SUBJECT: Service Instruction M20-88A - STABILIZER TRIM STOP/SCREW MODIFICATION
Dated 12/14/2016.

SERVICE INSTRUCTION M20-88A
Date: December 14, 2016

SUBJECT: STABILIZER TRIM STOP/SCREW MODIFICATION

INTRODUCTION: This Revision Supersedes M20-88 Dated 5/1/1990

Figure SI M20-88-1

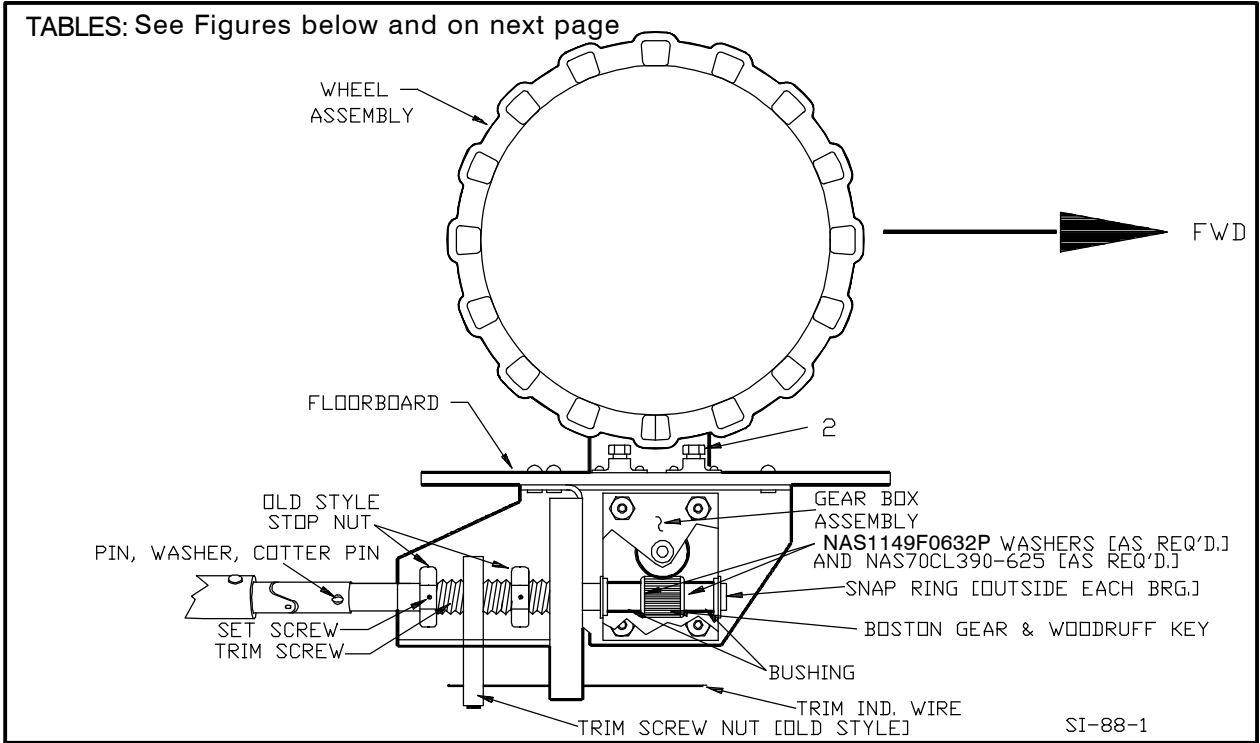
4. Remove cotter pin, washer and pin that secures trim tube universal joint to trim screw (Figure SI M20-88-1).
5. Loosen gear box bolts (Index 1, Figure SI M20-88-2) if not already done, and both NAS428-3-4 bolts (Index 2, Figure SI M20-88-2) to give slack in roller chain between upper and lower sprocket of trim control wheel assembly.

7. Remove roll pin, P/N RPA52-028-125-1125 holding lower sprocket, P/N 740049, to gear box shaft. Remove sprocket.
8. Loosen set screw, #6-32 x 1/8, in each existing trim stop so they will unscrew easily. Remove aft trim stop (DN stop) from trim screw (Fig. SI M20-88-1).

12. Measure and document longitudinal free play in trim screw shaft (end play) as assembled in the gear box assembly.
13. Remove forward snap ring from trim screw. Reference Figure SI M20-88-1
14. Lightly tap trim screw at forward end, with a plastic mallet, to drive trim screw, bushings, washers, gear and aft bearing from gear box assembly housing. Bearings are installed with loctite (Blue) at assembly, so some effort may be required to break it loose. **DO NOT DAMAGE BEARING OR HEATING THE HOUSING.**
15. When existing trim screw, and components attached to it, comes free from gear box housing, the bushings, washers, gears, woodruff key, snap ring and aft bearing will be removed. Retain components, except woodruff key, to place back on new trim screw (Fig. SI M20-88-1).

16. Install existing snap ring, P/N NAS51-37 on mid groove of new trim screw, P/N 740016-019. Re-assemble shim(s), bearing, bushing, washer(s), Boston gear, new woodruff key, washer(s) and spacer on new trim screw.

20. Measure longitudinal free (end play) of assembled trim screw to ensure that free (end play) does not exceed 0.010” Total Indicator Reading (TIR).
21. Add NAS70CL390-625, shim washer(s) under AN960-616L washer or under either snap ring as needed to maintain 0.010” TIR free (end play). Trim screw assembly will require removal from gear box housing again if shims are required under AN960-616L washer(s).

The new modified trim screw/gear box assembly should be shimmed for a maximum longitudinal free (end play) of 0.010” Total Indicator Reading (TIR).

Figure SI M20-88-2

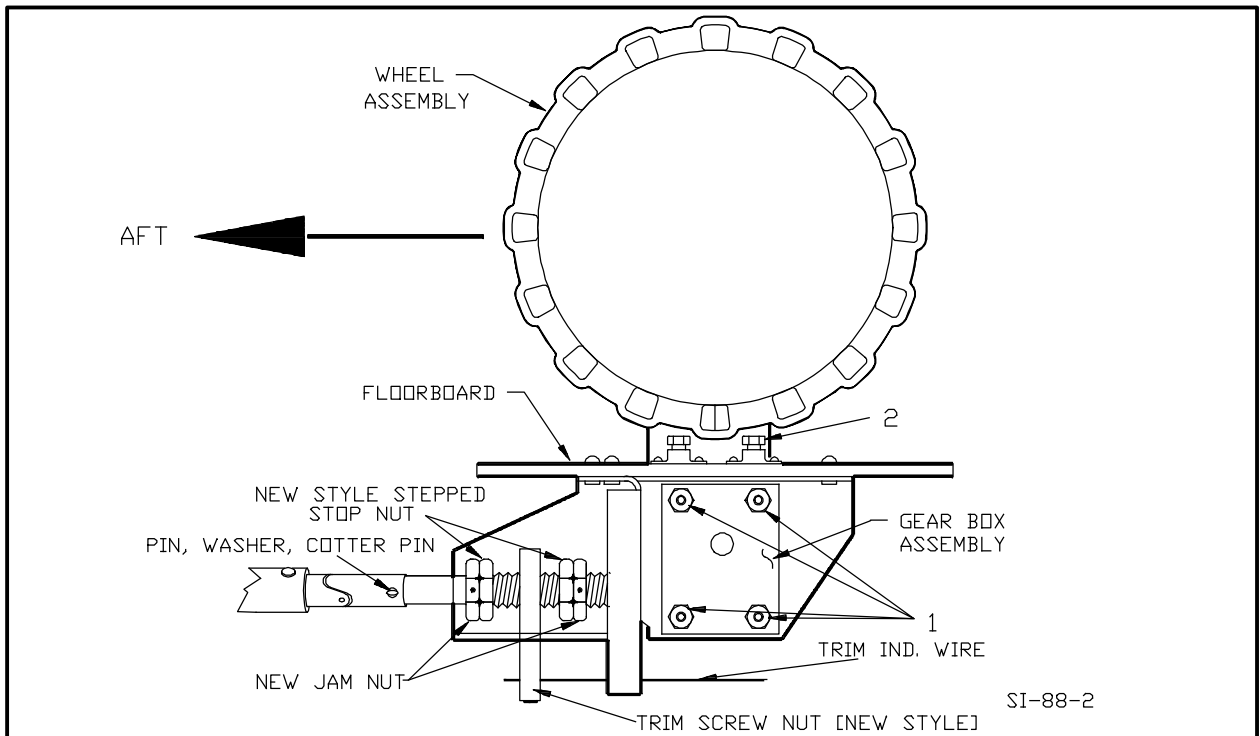
1. Remove belly access panels or smooth belly fairing to gain access to lower side of the trim control wheel assembly.
2. Remove trim indicator wire from trim screw nut by loosening set screw(s) that restrain trim wire.
3. Remove any brackets connected to gear box bolts (Index 1, Figure SI M20-88-2) both sides if required. Different models have different type of brackets.

22. Install one jam nut (UP stop side), P/N 740086-003 (M20J) or 740086-001 (M20K, M20L or M20M), on trim screw. Screw toward gear box housing leaving approximately 0.375 inch gap on threads between gear box and jam nut (Figure SI M20-88-2).
23. Install one stepped stop nut (UP stop), P/N 740086-007 (M20J) or 740086-005 (M20K, M20L or M20M) on trim screw. Screw toward gear box housing and against jam nut installed in step 22.

The stepped portion of stop nut must be facing away from gear box housing.

24. Position gear box/trim screw assembly to lower trim wheel assembly so new trim indicator nut, P/N 740086-011 (M20J) or 740086-009 (M20K, M20L or M20M) can be placed on trim screw and screwed in place to proper position within slotted bracket area. This is the reverse of Steps 9 & 10.
25. Install other stepped stop nut (DN stop) (stepped side toward trim indicator nut) on trim screw.
26. Install other jam nut on trim screw against stop nut (DN stop).
27. Reverse Steps 2 thru 7 to reposition gear box assembly back on trim wheel assembly. Do not tighten trim indicator wire set screw at this time. Position all other brackets but do not tighten bolts holding gear box assembly to trim wheel assembly (Fig. SI M20-88-2).

Each jam nut and stepped stop nut MUST be torqued together with wrenches, then the set screw in each jam nut tightened down on trim screw. Before proceeding further, run trim system through at least two complete nose up and nose down cycles to ensure stops are correct and did not move during the tightening of set screws or torquing procedures. Refer to Section 27-40-01 for proper negative and positive angles for stabilizer in full nose up and full nose down positions.
